UNITED STATES PATENT AND TRADEMARK OFFICE

APPLICATION NO.	FILING DATE	FIRST NAMED INVENTOR	ATTORNEY DOCKET NO.	CONFIRMATION NO.
10/645,035	08/21/2003	Michael E. Ring	CRD 01482	7356

Office Action Summary	Application No.		Applicant(s)	
	10/645,035		RING ET AL.	
	Examiner		Art Unit	
	Melody M. Burch		3657

DETAILED ACTION

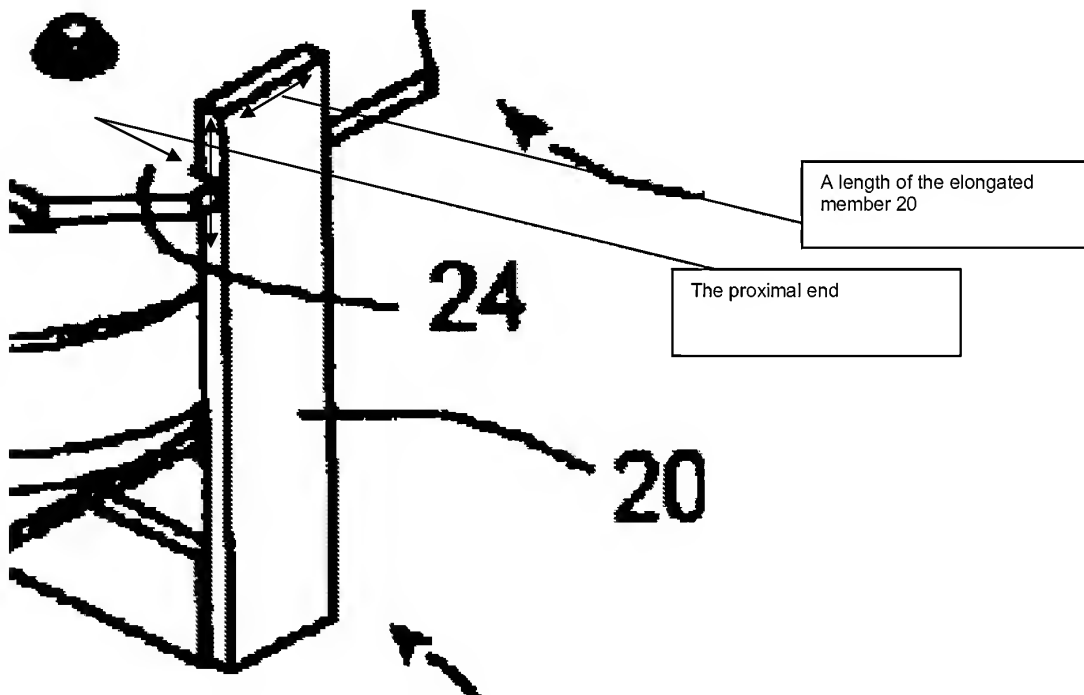
5. Applicant's arguments filed 5/27/10 have been fully considered but they are not persuasive. Claim 6 has been amended to include the limitation "said proximal end disposed transverse to a length of said each of said pair of elongated members" in order to overcome the current interpretation of Johnson. Examiner notes; however, that the amended does not overcome the following interpretation of Johnson:

As clearly shown in the annotated drawing above the labeled proximal end is disposed transverse to a length of the elongated member 20 as labeled and as broadly recited.
